**CITY OF CHESTERFIELD
PLANNING COMMISSION MEETING
MONDAY - APRIL 9, 2007**

Planning Commission Staff Report

PRELIMINARY DEVELOPMENT PLAN
CONWAY POINT OFFICE BUILDING

Designed	SWQ
Drawn	SLH
Checked	EAS
Date	09/14/06
Project Number	98218.3
Sheet Number	1 of 3

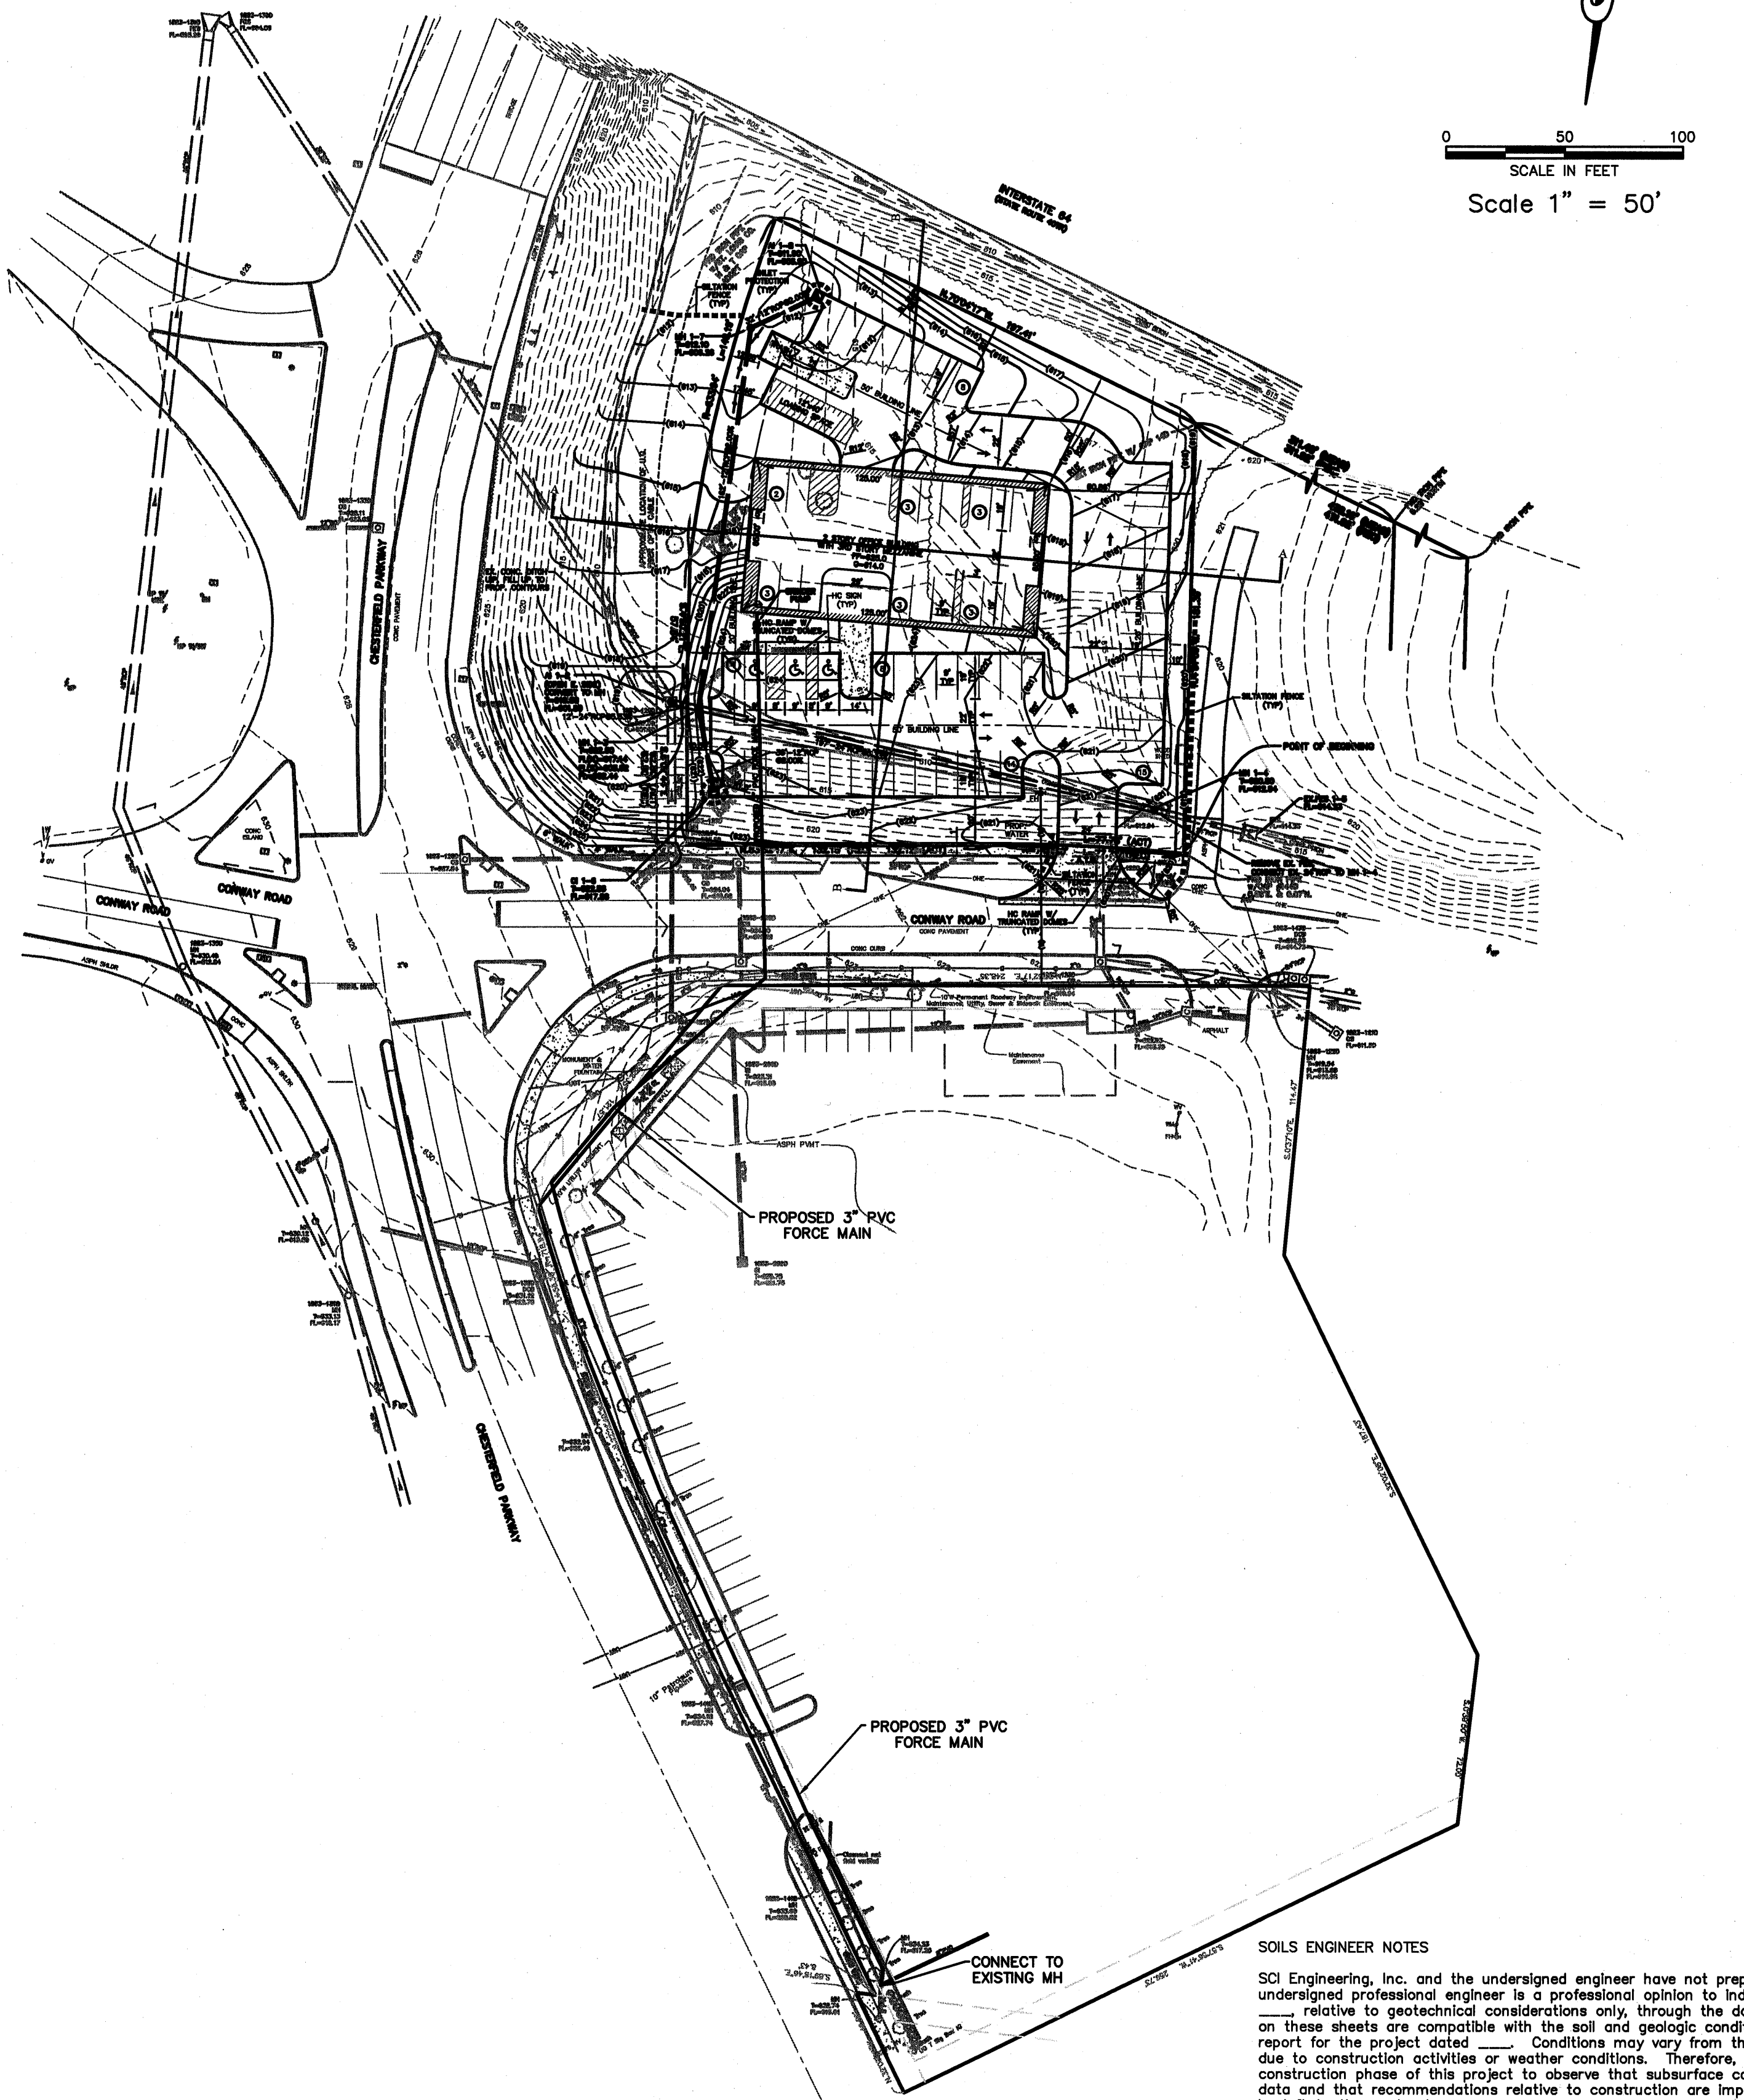
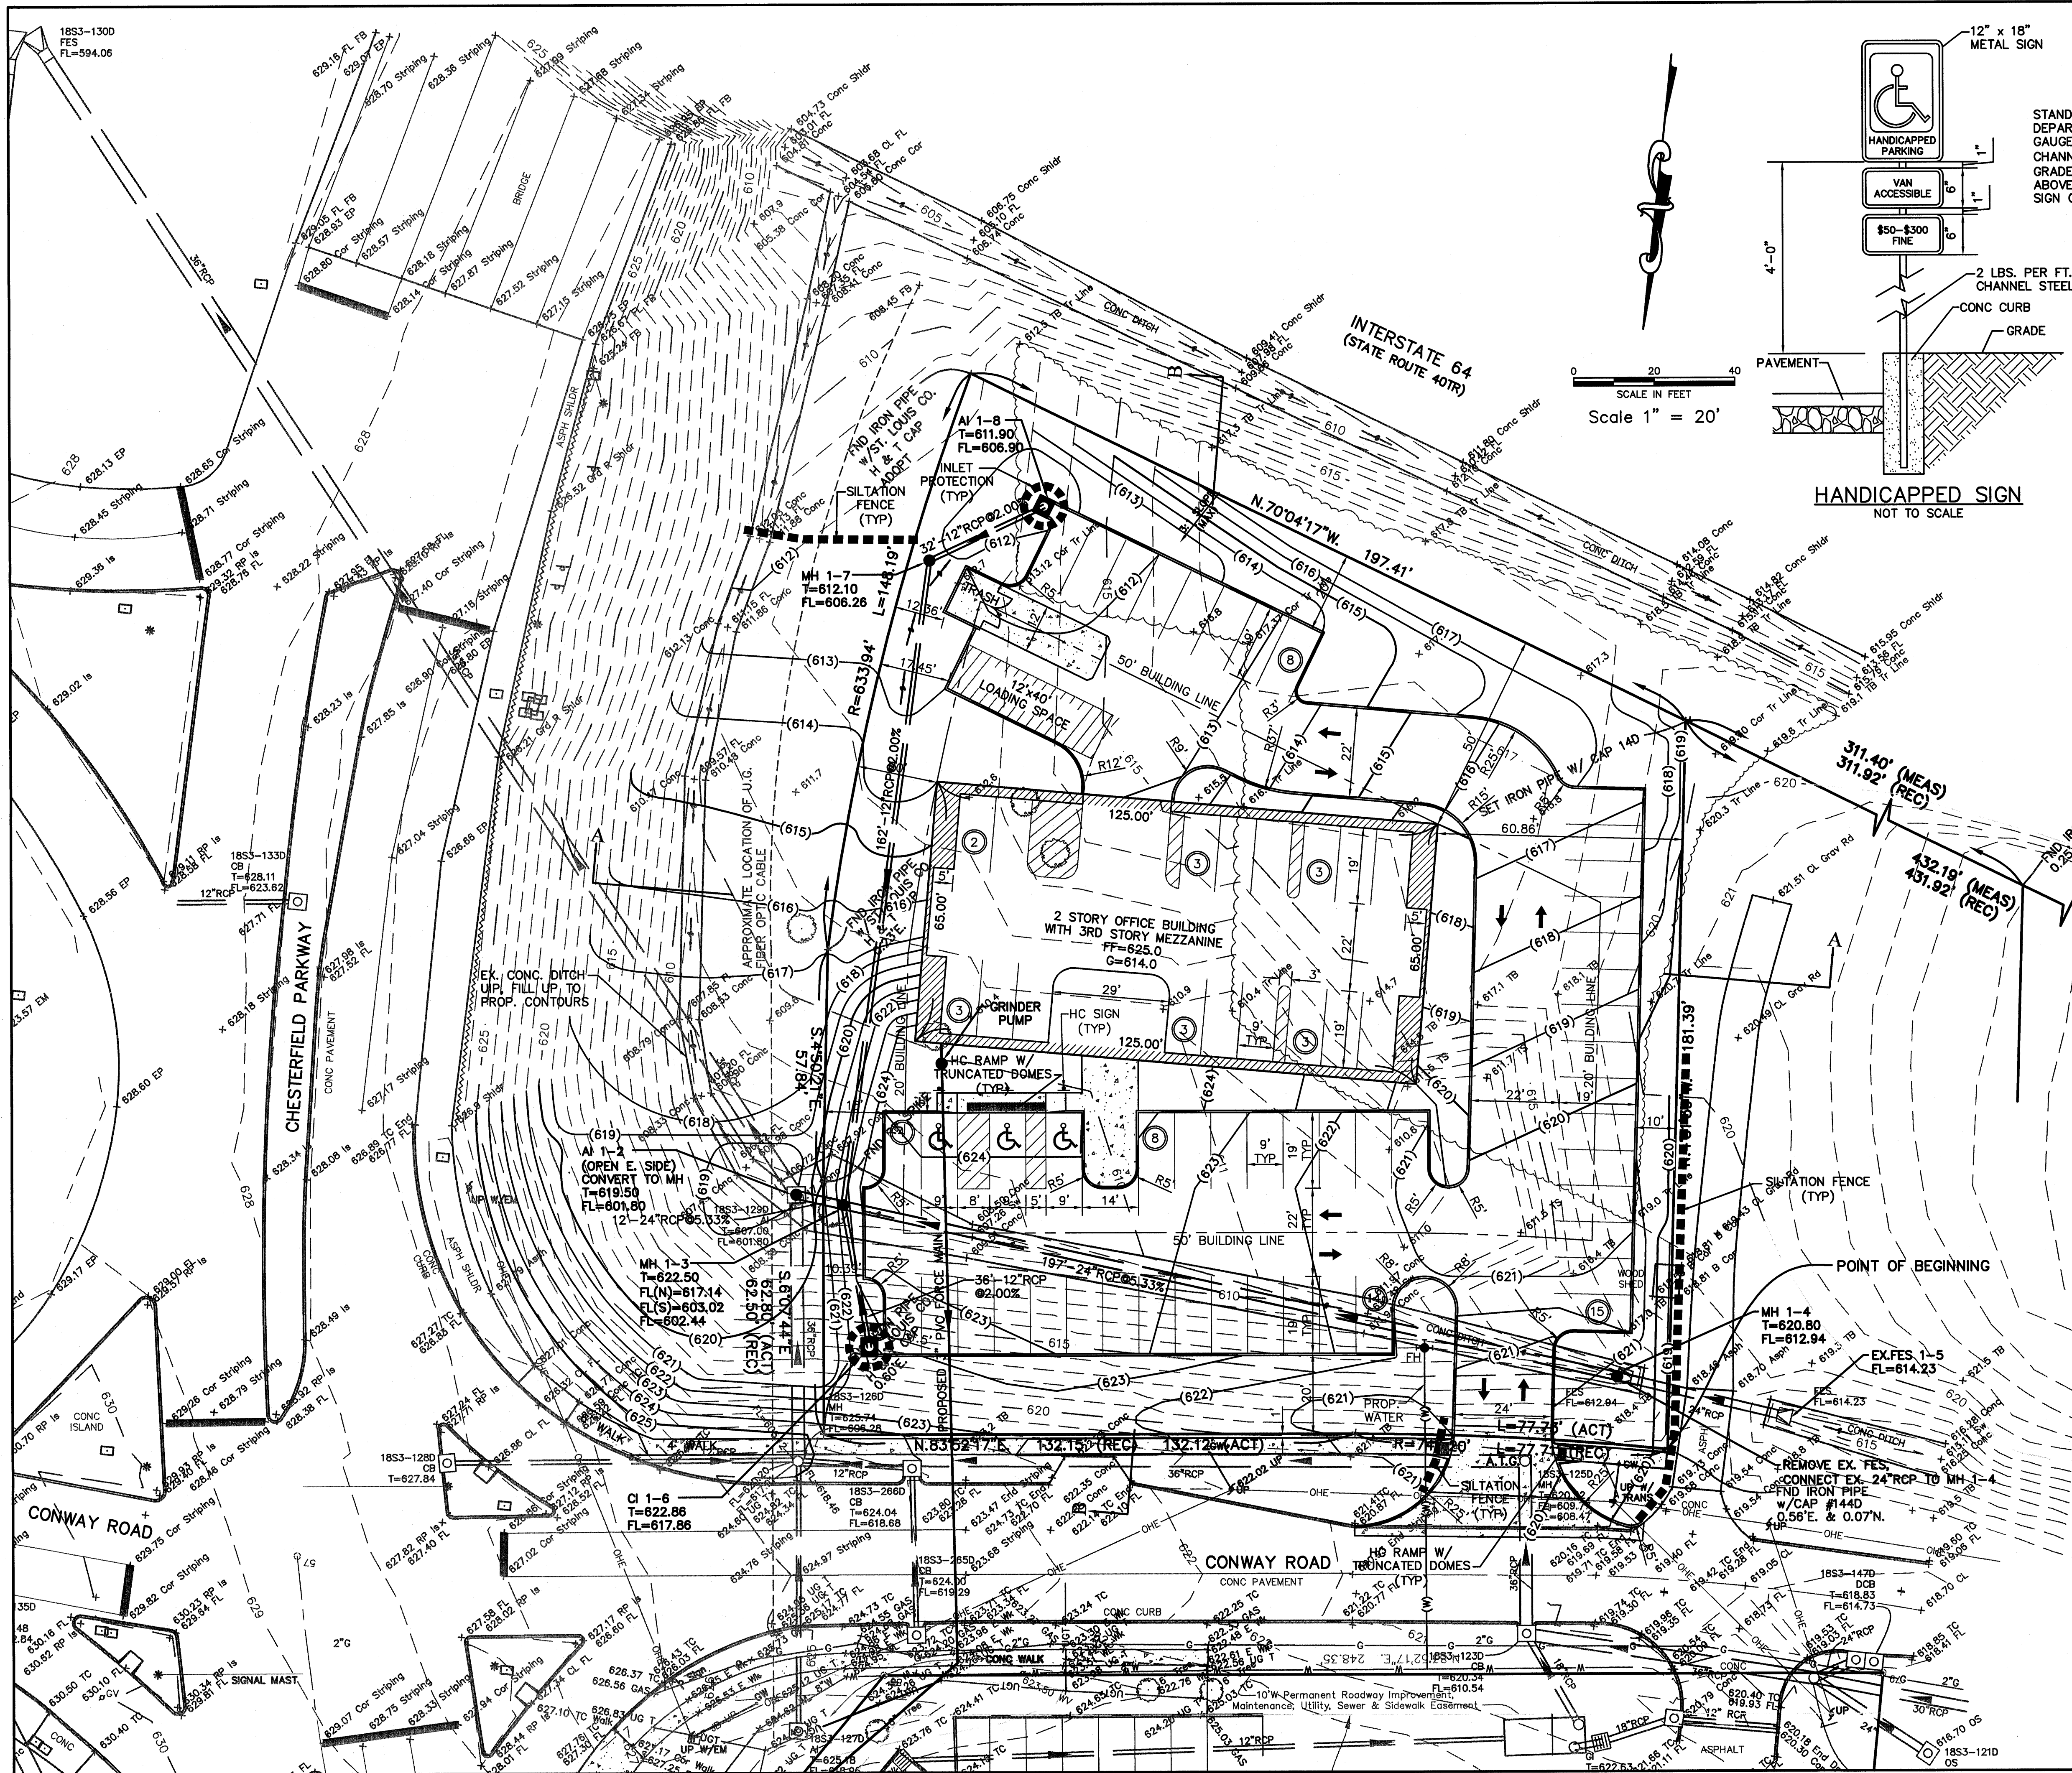
5. On sheet 1 of 3, portions of the sanitary force main appear to be located outside the existing utility easement. Either the force main alignment will require revision or additional easements obtained. This issue need not be addressed at this time, but will be reviewed in greater detail during review of the Improvement Plans.
